# 2009 APPLICATION FORM

**Job No. J8S0724, Bridge No. A7501 Route H (Glenstone Avenue) County / LPA Greene**

**Bridge Alternate Technical Concept Proposal - Revision No. 1 - Emery Sapp & Sons, Inc.**

**Bridge A7501**

GENERAL ELEVATION

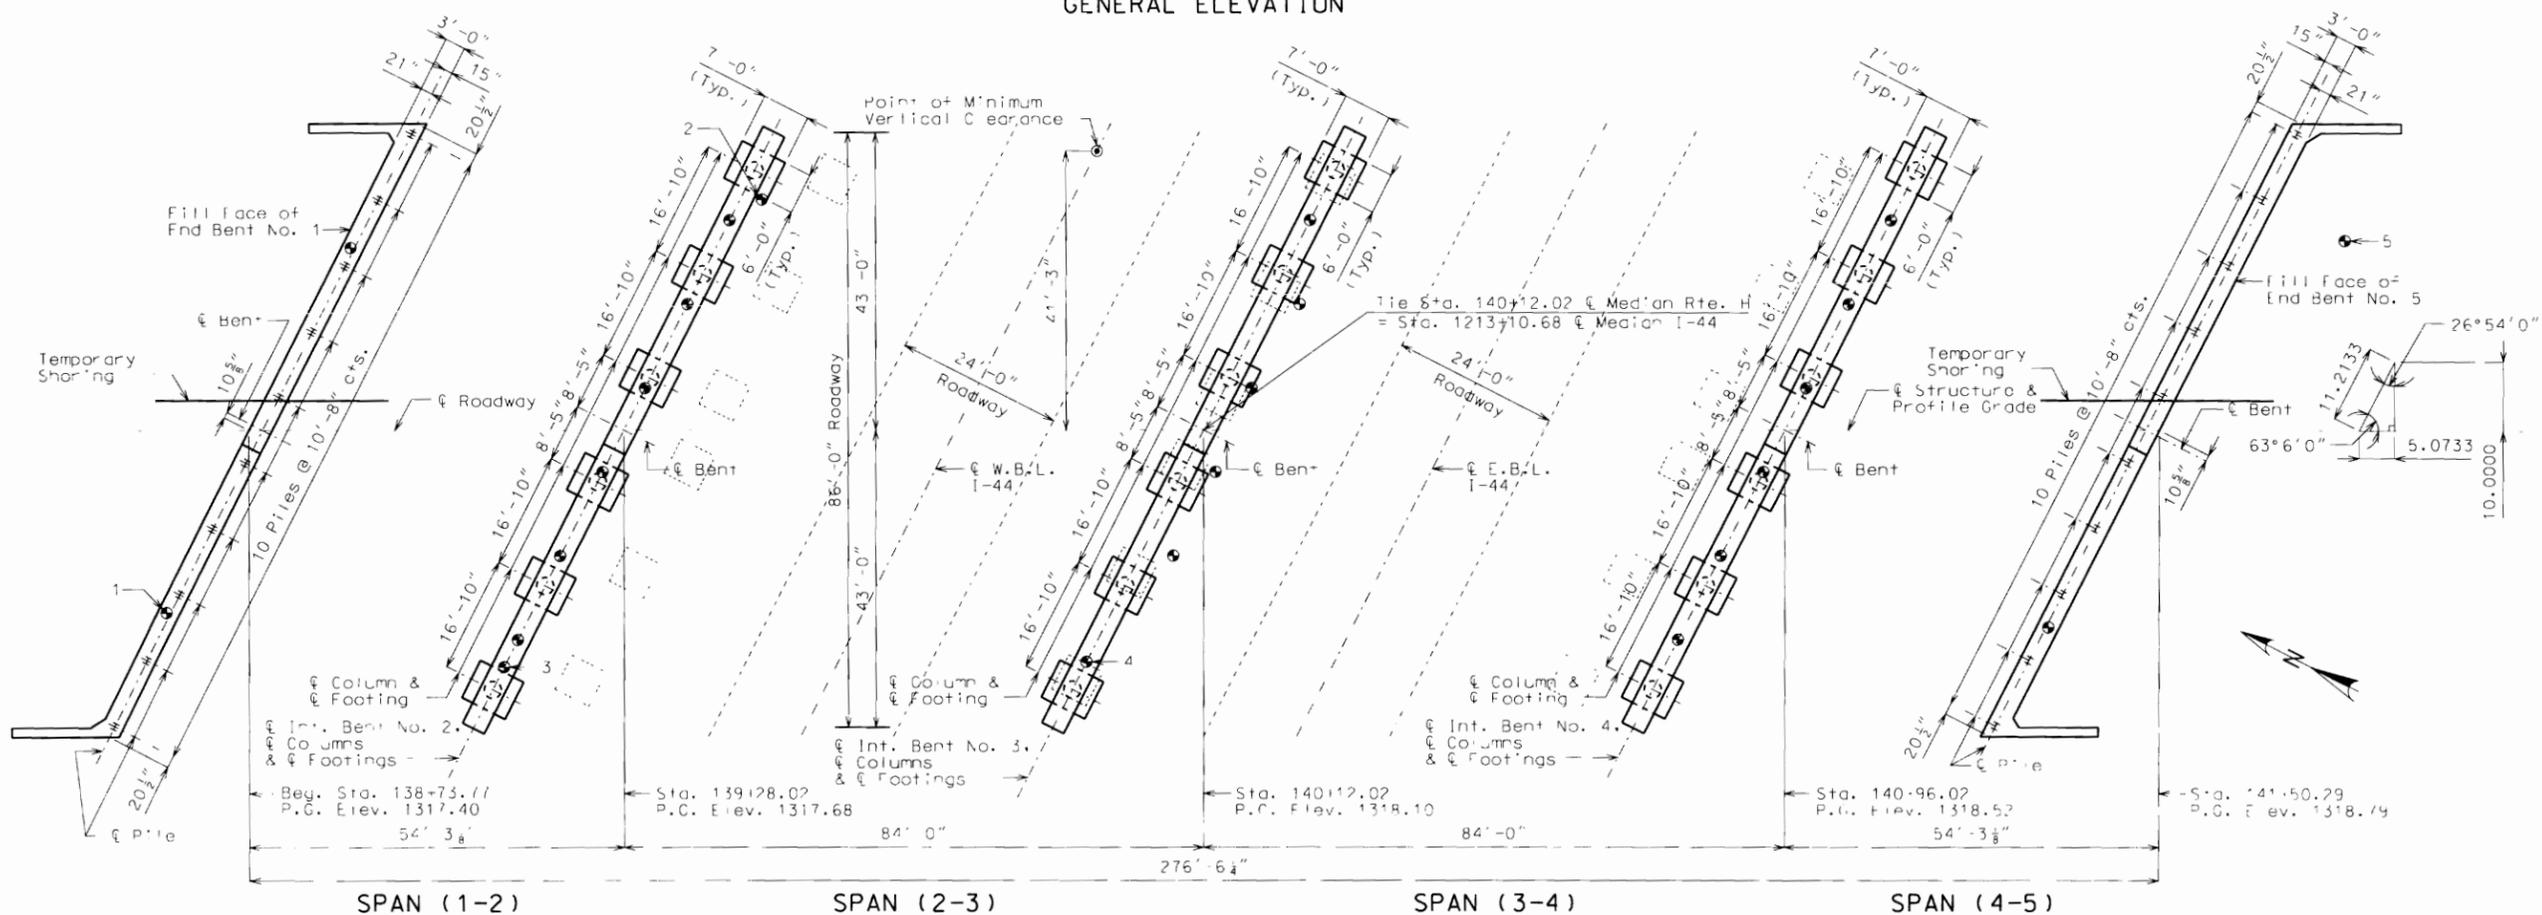
This Alternate Technical Concept changes the original bridge design from a 4 span bridge with spill-fill slopes to a 2 span bridge with MSE walls at the abutments to retain the fill. The new end bent locations will be at original design locations for interior bents 2 and 4.

Length = 276.52 ft  
 Spans = 4 each  
 Span Lengths = 53' - 84' - 84' - 53'  
 Width = 88.67 ft

1. The bridge substructure has 2 end bents and 3 interior bents. The end bents consist of a 99.5 ft bearing beam / 13 ft wing on 10 - HP12x53 piling. The interior bents consist of a 96.67 ft cap beam supported on 6 - 30" concrete columns on 6' x 7' spread footings keyed into rock.
2. The bridge superstructure consists of a CIP concrete deck with partial use of precast deck panels and conventional forming on Type 6 ( 54" ) pre-stressed concrete I-girders.
3. The bridge has conventional Safety Barrier Curb allowing for either CIP or slipforming option.
4. An 8" raised median barrier will be constructed on deck with use of drilled resin anchors.

Length = 171 ft  
 Spans = 2 each  
 Span Lengths = 84' - 84'  
 Width = 88.67 ft  
 Use MSE Wall at Abutments

1. The proposed substructure will consist of 2 end bents and 1 interior bent. The end bents will be the same dimensions but will need to be designed for heavier loads due to longer girder spans being placed on them. The one intermediate bent will be as originally designed in center of I-44 median.

2. The bridge will be shortened by the use of MSE walls at the new abutment locations. This proposal and it's estimated cost savings are based on placing the new end bents at original Bent 2 and 4 locations and building a MSE wall approximately 3 ft in front of the bearing beam.

3. The proposed superstructure will consist of the use of the originally designed pre-stressed concrete I-girders for Spans 2 and 3 using the same combination of precast deck panels and conventional forming.
